FIELD SERVICE BULLETIN

FSB Number: LVCCFSB2006 – 204 Rev (A)

Subject: 3G V3x – Camera Lens Lifting

Phone Models: 3G V3x

Fig 4. Closed and Open Cell Foam

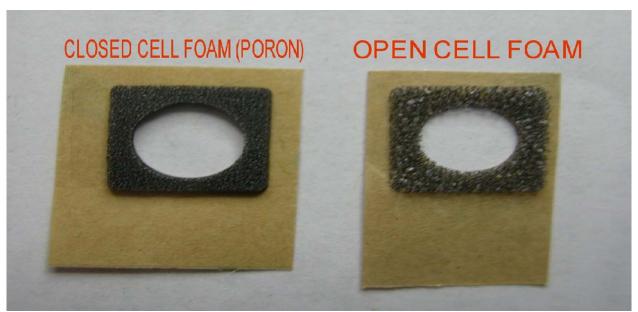
Service is aware of an issue on the V3x where the 2mp camera lens is lifting; above flip outer surface significantly, in excess of cosmetic specification of 0.22mm, see Fig 1. Analysis revealed excessive force applied on the camera lens adhesive. Contributors to the force are the thickness (1.0mm) and density (9 pounds) of the poron camera gasket and the flip housing date code height, which exceeded the specification.

Production material shipped from Foxconn Feb 21 and beyond will consist of Open Cell Gasket for 2mp camera gasket (3271688B04), see fig. 4

- Replace closed gasket with the open cell gasket (PN 3271688B04) following 2MP LENS REMOVAL PROCEDURE and 2MP LENS PLACEMENT as described below.
- 2. Follow normal post repair testing procedures.
 - a. Verify no contamination between imager and imager lens.
 - b. Test external imager for foreign material in view finder.
